# UCM Series IP PBX Firmware Release Notes

# FIRMWARE VERSION 1.0.33.22

## CHANGES SINCE FIRMWARE VERSION 1.0.33.21

Figure 1 - Extension Call Statistics

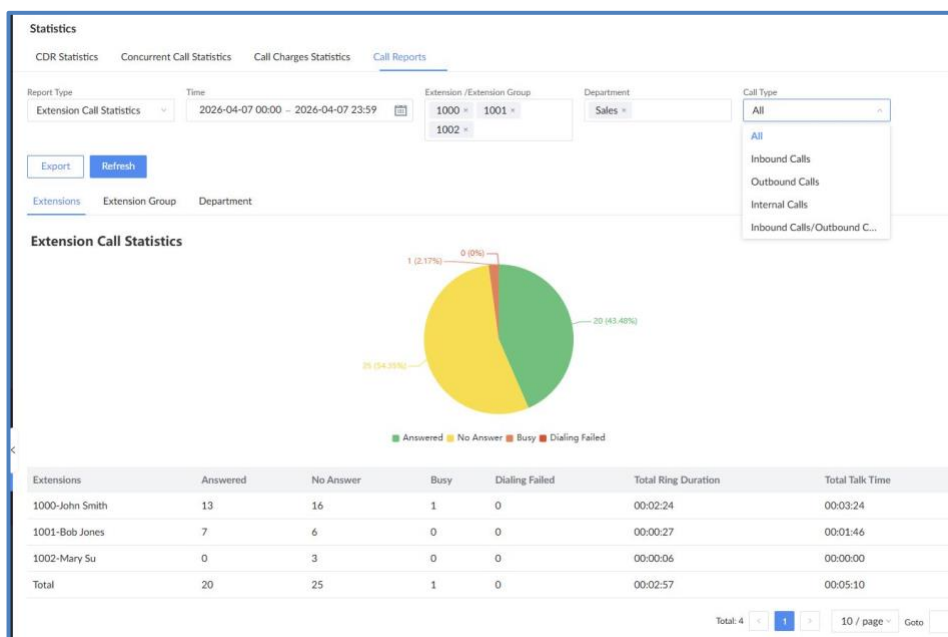
- **Extension Call Statistics** – Shows call statistics of selected extensions/extension groups/departments over specified time periods and call types.

Figure 2 - Extension Call Activity

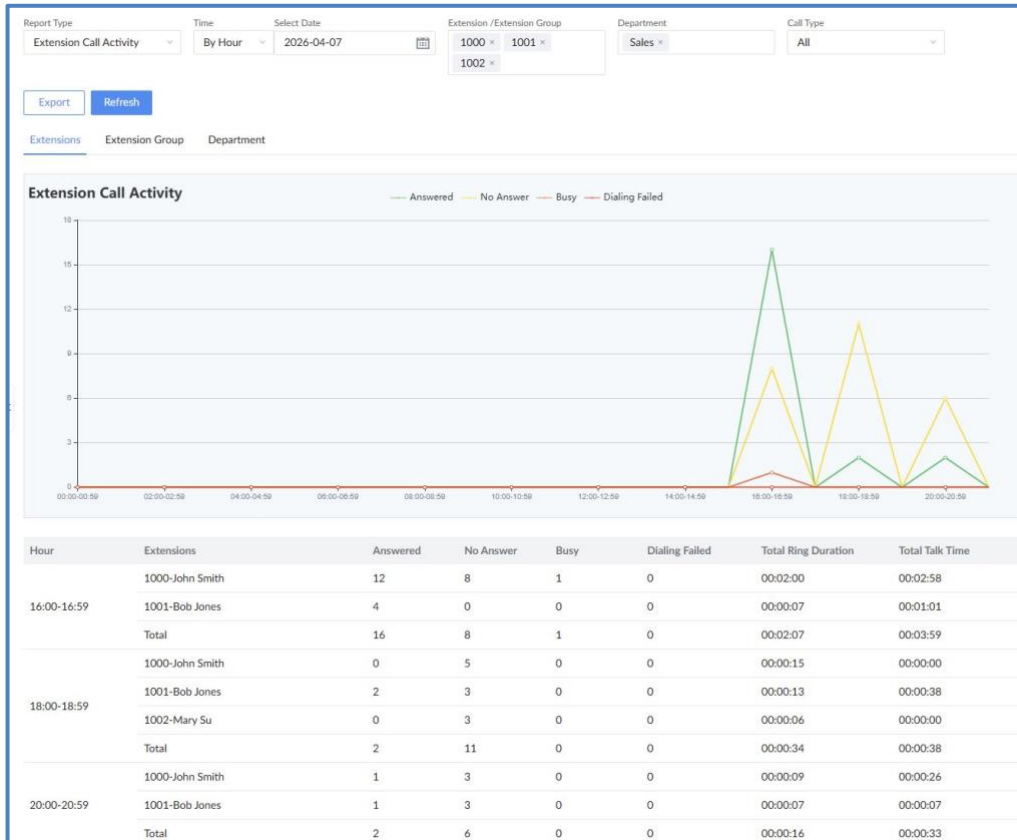
- **Extension Call Activity** – Shows how calls and selected call types were handled by the specified extensions/extension groups/departments over the specified time periods.

Figure 3 - IVR Standard Key Press Statistics

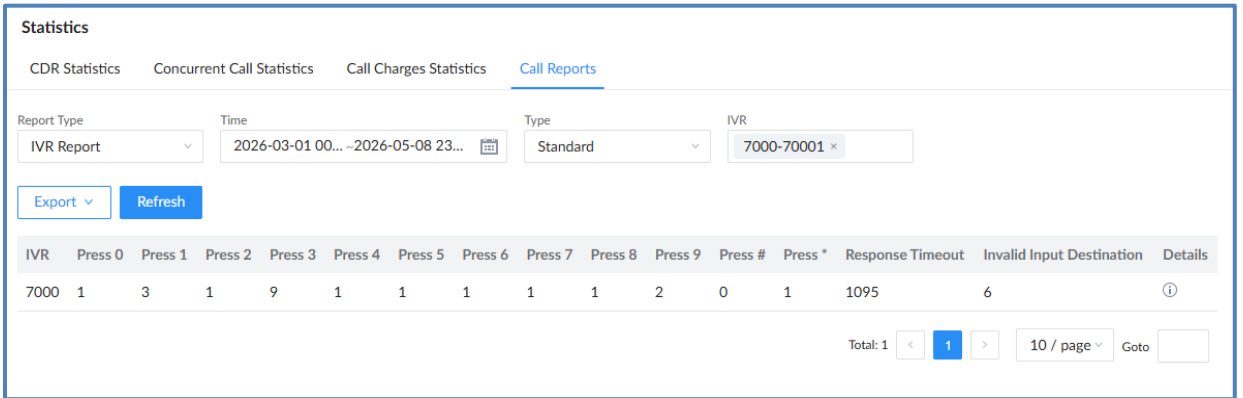
- **Type** indicates the IVR key press event format to see statistics for.
    - *Standard* refers to the typical 0-9, \*, # key press events along with invalid input and response timeout events. Statistics for each key press event type will be calculated.

Figure 4 - IVR Custom Key Press Event Statistics

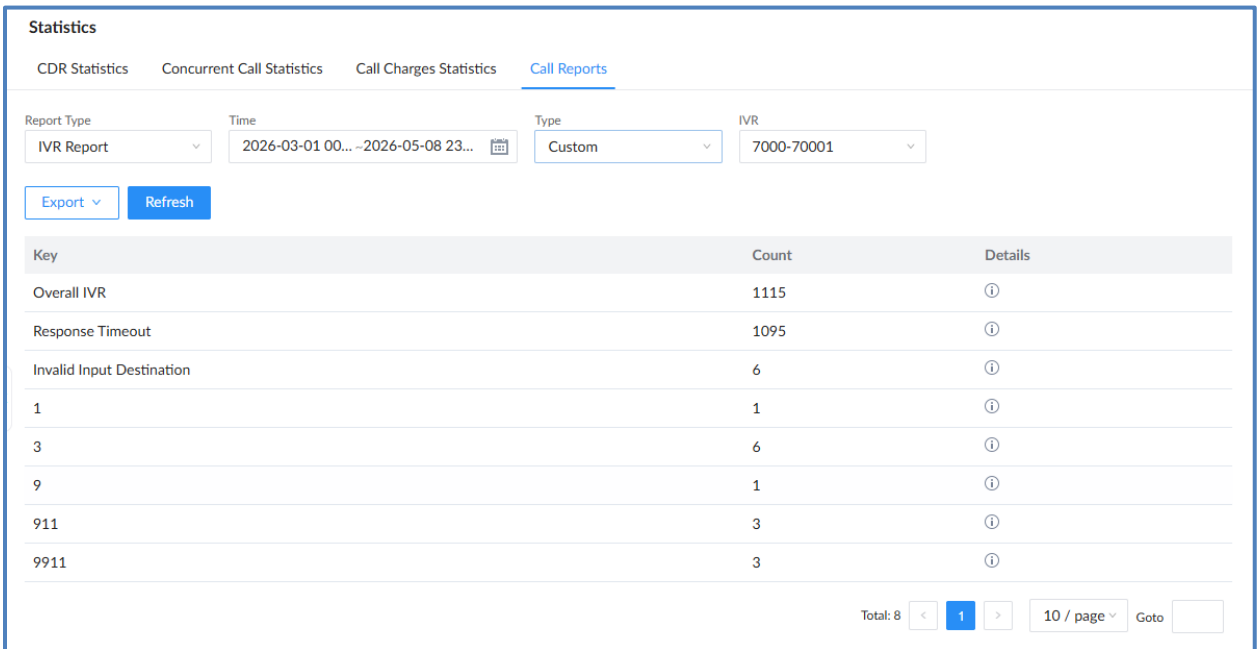
- *Custom* refers to customized key press events that support key combinations, allowing for more options beyond the standard 0-9, \*, and # single keys. However, reports for *Custom* type will only show data for overall IVR call-ins, response timeouts, and invalid inputs. It will not provide statistics for each custom key press event.

Figure 6 - Integration of Collaboration Platforms

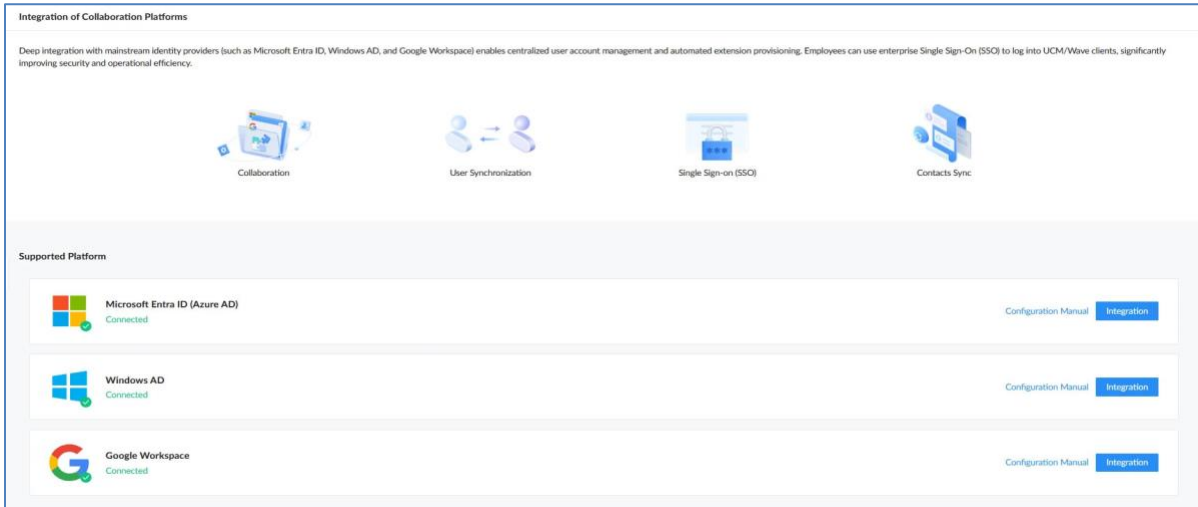
Microsoft Entra ID (Formerly Azure AD), Windows AD, and Google Workspace are now all under the new **Integration of Collaboration Platforms** page under the **Integrations** section, providing a centralized location for 3rd party user platform integration configuration.
